4. REVISIONS TO THE DRAFT EIR TEXT

4.1 INTRODUCTION

4.2 DESCRIPTION OF CHANGES

**Figure 4.12-1
Study Area**

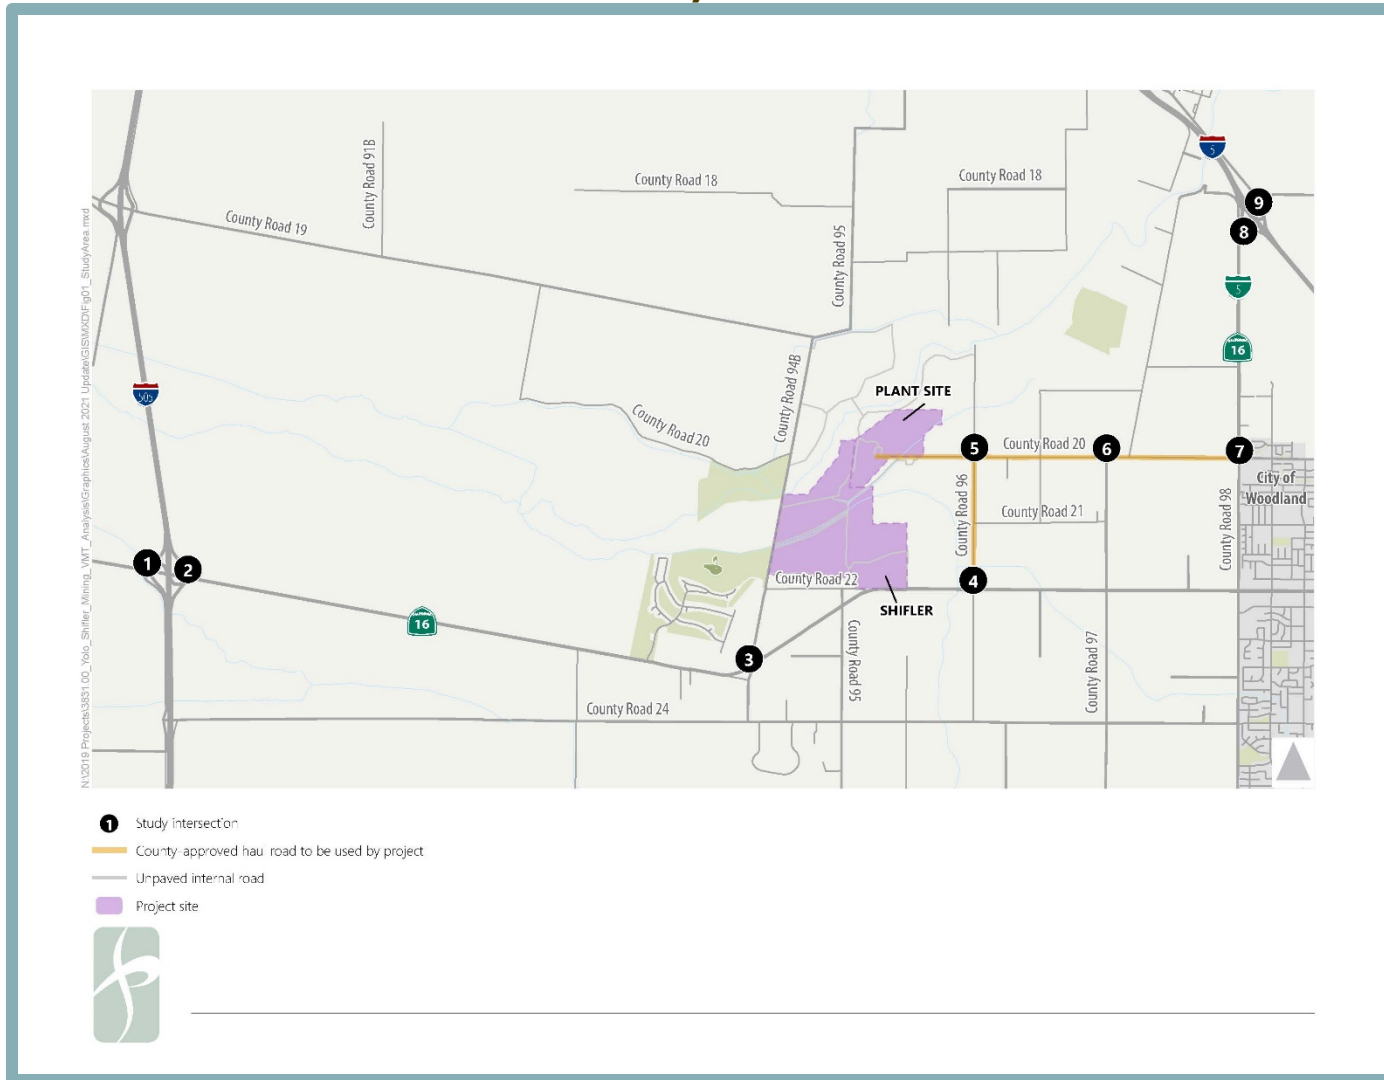
Page 4.12-5, Draft EIR, Chapter 4.12, Section 4.12.2, Figure 4.12-1 is hereby updated with a more detailed figure that has been prepared to show the internal circulation routes associated with the proposed project.

Figure 6-5
Moore Canal Avoidance Alternative – Project Site Farmland Acreage Totals

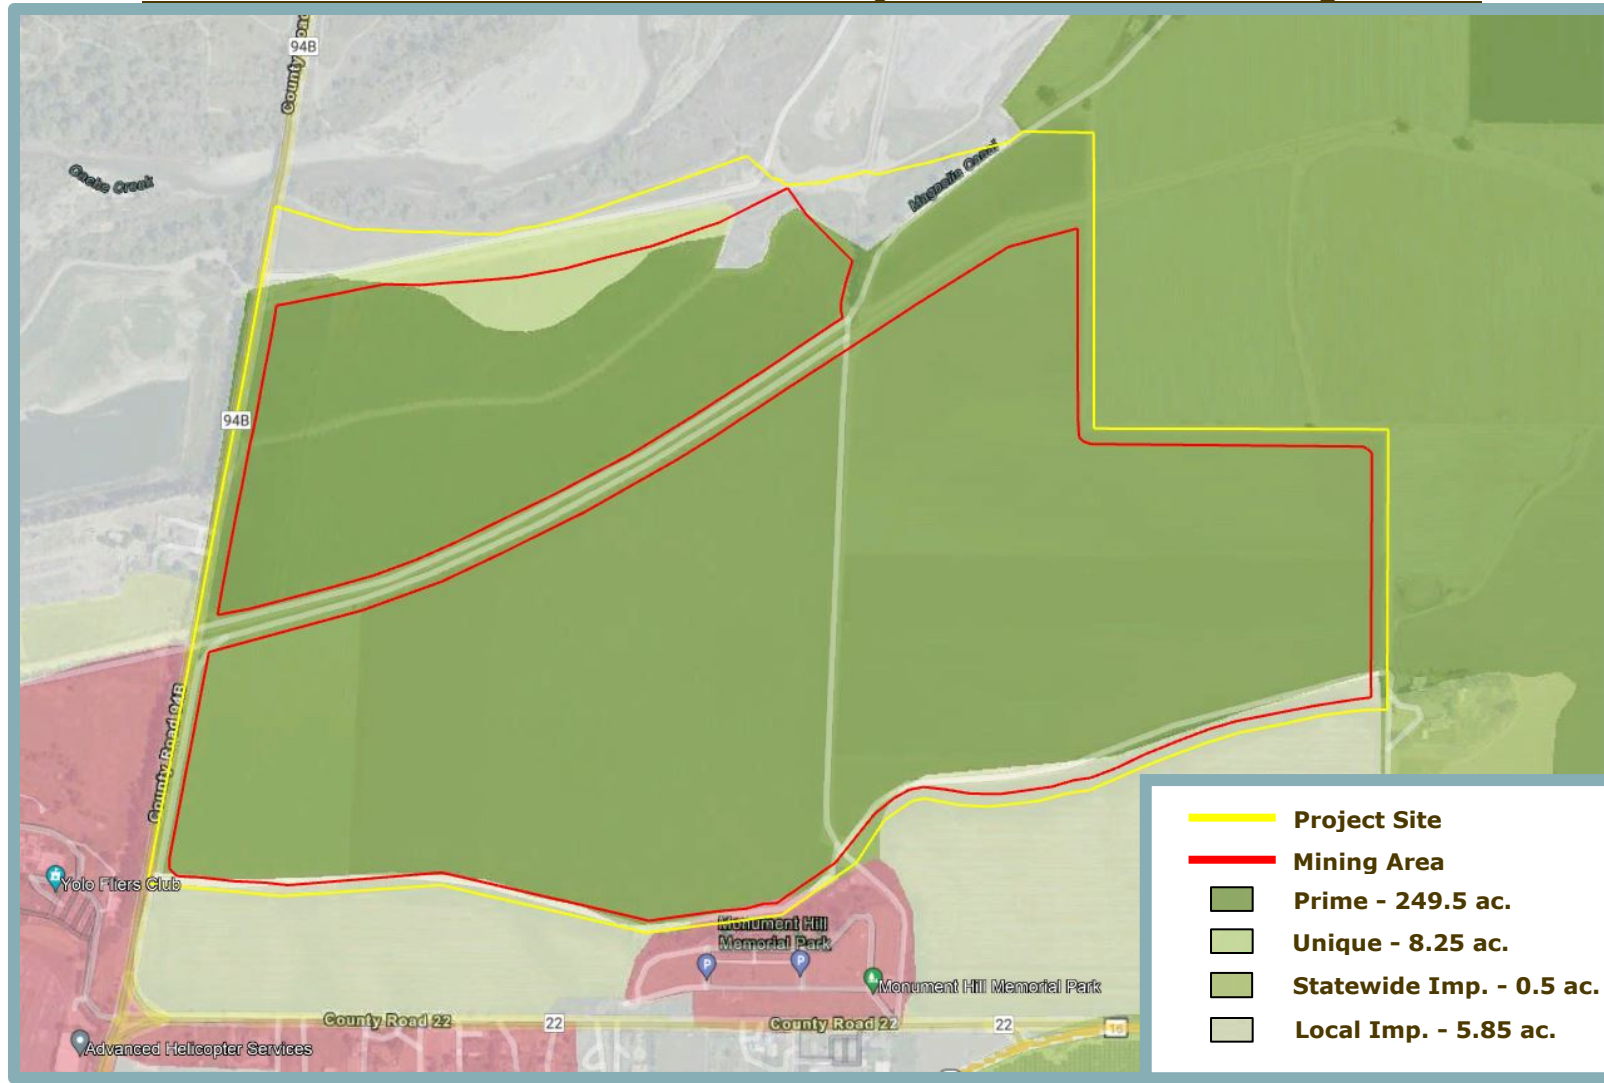
The Moore Canal Avoidance Alternative would result in similar acreage of impacts to agricultural resources compared to the proposed project. As shown in Figure 6-5, of the 264.1-acre mining and reclamation area, 249.5 acres are mapped by the California Department of Conservation as Prime Farmland, 8.25 acres are mapped as Unique Farmland, 0.5 acres are mapped as Farmland of Statewide Importance, and 5.85 acres

Page 6-24, Draft EIR, Chapter 6, Section 6.3, the description and analysis of the Moore Canal Avoidance Alternative is hereby revised to include Figure 6-5 and Figure 6-6 (on the following pages), which show the Farmland acreages and the location/impact of existing native oaks associated with the alternative, respectively. All subsequent figure numbers in Chapter 6 following the new Figures 6-5 and 6-6 are hereby revised, accordingly.
